Work Order ID 131479

Item Name: Fwd Crosstube - High 407

DRAWING NO. D407-667-145	TITLE CROSSTUBE ASS'Y (407 HIGH FWD)	REV. C	DART AEROSPACE LTD ENGINEERING ORDER		D.E.O. NO. D407-667-145-C-1	SHEET NO. SHEET 1 OF 1	SCALE NTS
DRAWN <i>JP</i>	CHECKED <i>ASS</i>	MFG. APPR. <i>IB</i>	APPROVED <i>WD</i>		DE APPR. <i>HA</i>		
DATE 11.07.15	DATE 11.07.22	DATE 11.07.22	DATE 11/07/22		DATE 11.07.21

DRAWING NO. D407-667-145	TITLE CROSSTUBE ASS'Y (407 HIGH FWD)	REV. C	DART AEROSPACE LTD ENGINEERING ORDER		D.E.O. NO. D407-667-145-C-2	SHEET NO. SHEET 1 OF 1	SCALE NTS
DRAWN AJS	CHECKED	MFG. APPR. <i>E</i>	APPROVED <i>140</i>	DE APPR. <i>[Signature]</i>			
DATE 12.08.02	DATE 12.08.02	DATE 12.08.02	DATE 12.08.02	DATE 12.08.02

DETAIL P
 BONDING STRAP INSTALLATION 2 PL

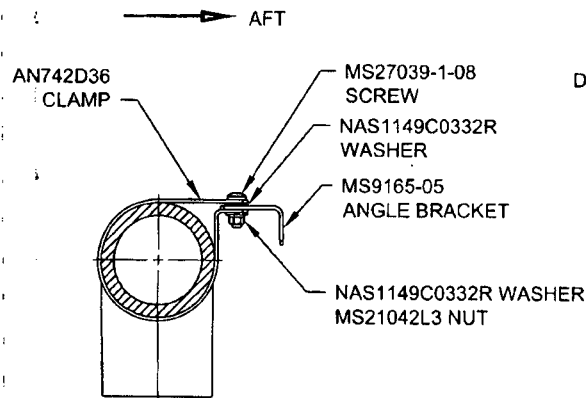
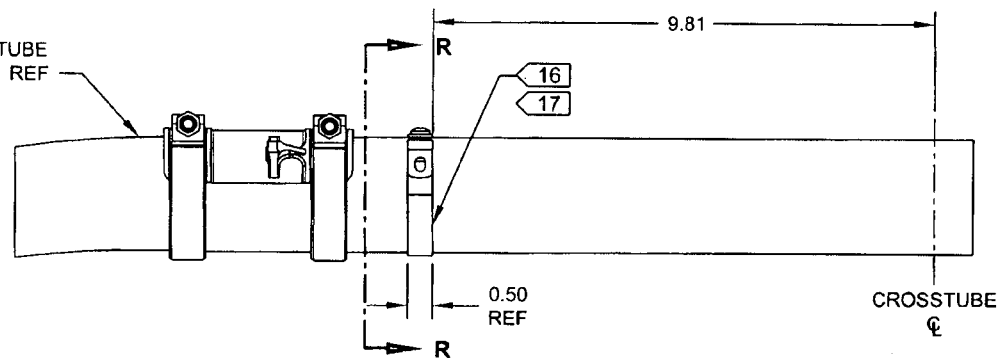
ADD ELECTRICAL GROUNDING STRAP

ITEM	QTY -145	PART NUMBER	DESCRIPTION
1	X	D407-667-145	CROSSTUBE ASSEMBLY (407 HIGH FWD)
⚡			
10	2	AN742D36	CLAMP
11	2	MS9165-05	ANGLE BRACKET
12	2	MS21042L3	NUT (OR MS21042-3)
13	2	MS27039-1-08	SCREW
14	4	NAS1149C0332R	WASHER (OR AN960C10L)

- 16) MASK AREA UNDER CLAMP PRIOR TO PAINTING
- 17) SEAL EDGES WHERE AN742D36 CLAMP MEETS WITH THE CROSSTUBE USING SIKAFLEX-241/-291 OR MIL-S-8802 CLASS B2 OR PROSEAL 890 SEALANT
- 18) PERFORM RESISTANCE CHECK TO ENSURE MAX RESISTANCE IS 10 MILLIOHMS
